FORM APPROVED
OMB NO. 1004-0137
Expires: January 31, 2018**SUNDRY NOTICES AND REPORTS ON WELLS**
*Do not use this form for proposals to drill or to re-enter an abandoned well. Use form 3160-3 (APD) for such proposals.***SUBMIT IN TRIPLICATE - Other instructions on page 2**5. Lease Serial No.
NMNM053434

8. Well Name and No.
LEA UNIT 2

Legacy Reserves will be recompleting the Lea Unit #2 uphole by opening pay in the Bone Spring formation. An earlier Sundry Notice requested permission to P&A the well, please disregard that request. Legacy's planned procedure to recomplete the well is as follows:

Lea Unit 2
30-025-02428
Conditions of Approval

PROPOSED WELLBORE DIAGRAM.

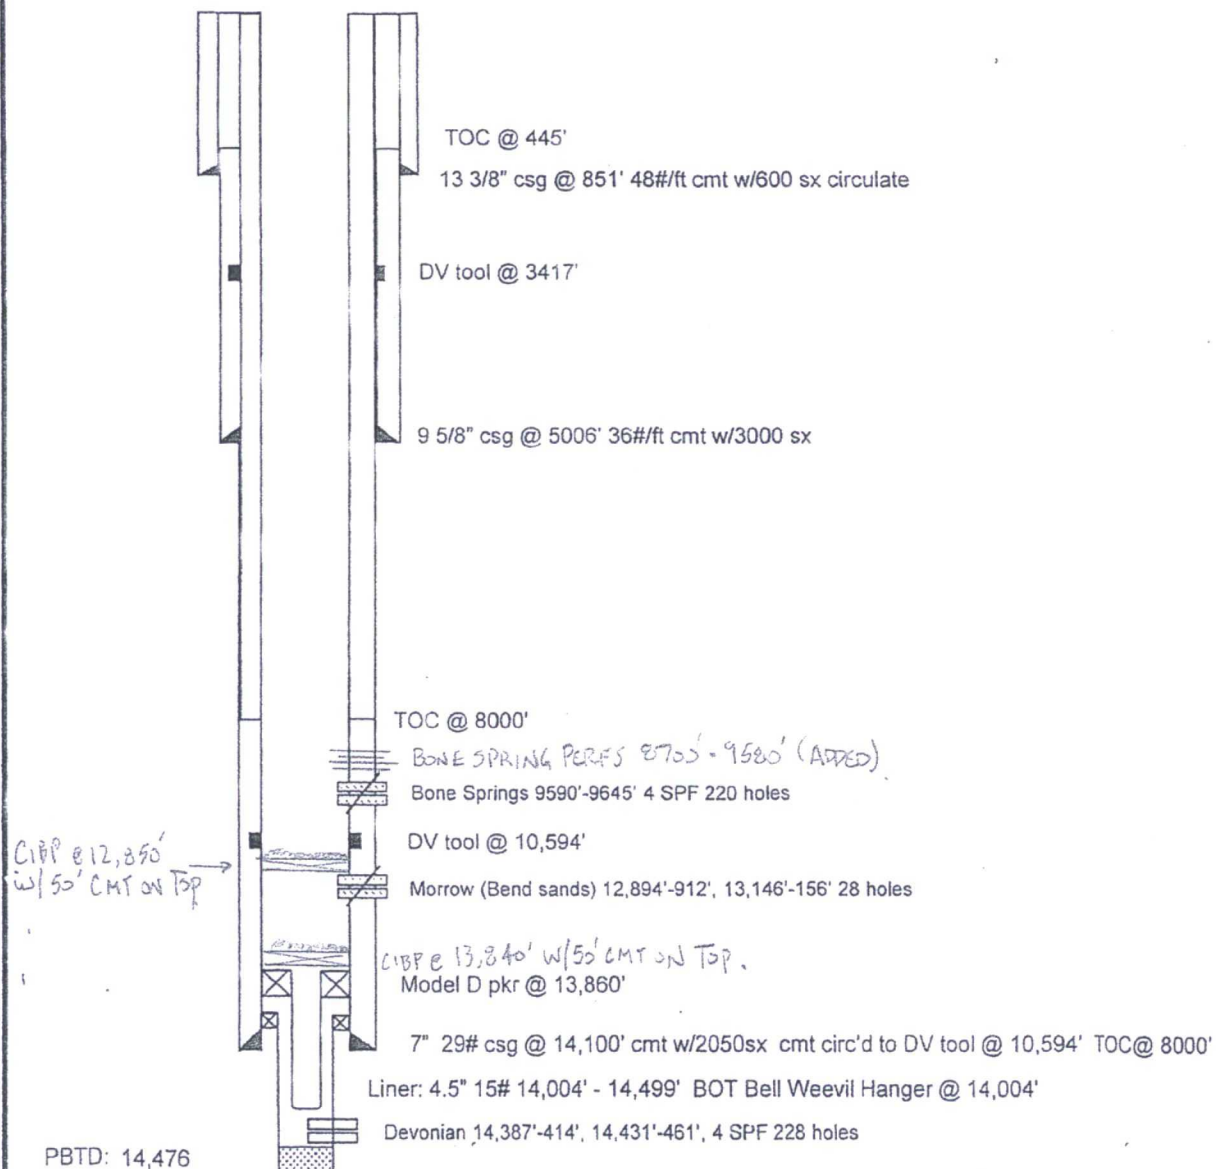
- Attempt to get passed collapsed casing @~12,348'.
- If successful set CIBP @~13,840' w/50' cmt on top.
- If successful set CIBP @~12,850' w/50' cmt on top.
- If not successful set CIBP as deep as possible w/50' cmt on top.
- Set CIBP @~12,300' w/50' cmt on top.
- Add Bone Spring pay from ~8,700'-9,580'.
- Return well to production.

Following plugging procedure needs to be completed before proceeding to Bone Spring recompletion operation:

- i. Model D packer at 13,860' needs to be pulled out.
 - ii. Spot class H cement from 14,415' – 14,050'. WOC and Tag.
 - iii. Spot class H cement from 14,054' – 13,954'.

- iv. Set CIBP at 12,760' with 25 sacks of class H cement on top. WOC and Tag.
 - v. Spot class H cement from 11,053' – 10,843'. WOC and Tag.
 - vi. Spot class H cement from 10,644' – 10,544'.
-
